Customer Service Bulletin

SLM Electronics, Inc. Saint Louis, Missouri

CSB0006

Internal fuses in these production units can fail after repeated on/off cycling

Figure 1: Removal of the internal fuses

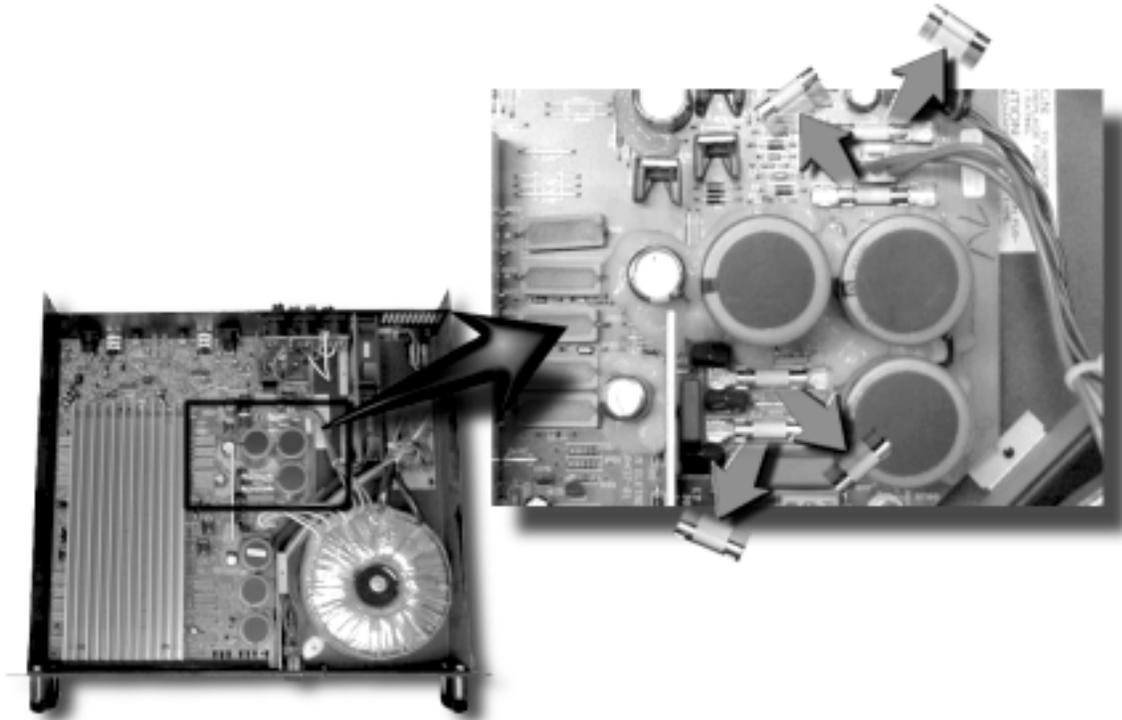
1. Unplug the unit.
2. Remove the 9/64" drive socket screw from the top-center of the faceplate. Remove the ten small phillips-head screws from the top cover (three along each side, three along the rear, and one on the top). Remove the top cover.
3. Locate the four internal fuses (F1 - F4), remove them as shown in Figure 1 on page 2 and discard them.
4. Replace each of the four fuses with SLM part number 23-301-05 3AG 1A slo blo fuses. (Note that even though the replacement fuses are longer than the original fuses, they still snap down into the same fuse holders.)
5. Replace the top cover and tighten the screws. Do not overtighten.

Remove T1A fuses, four places (F1 - F4) - replace with 3AG 1A slo-blo #23-301-05.
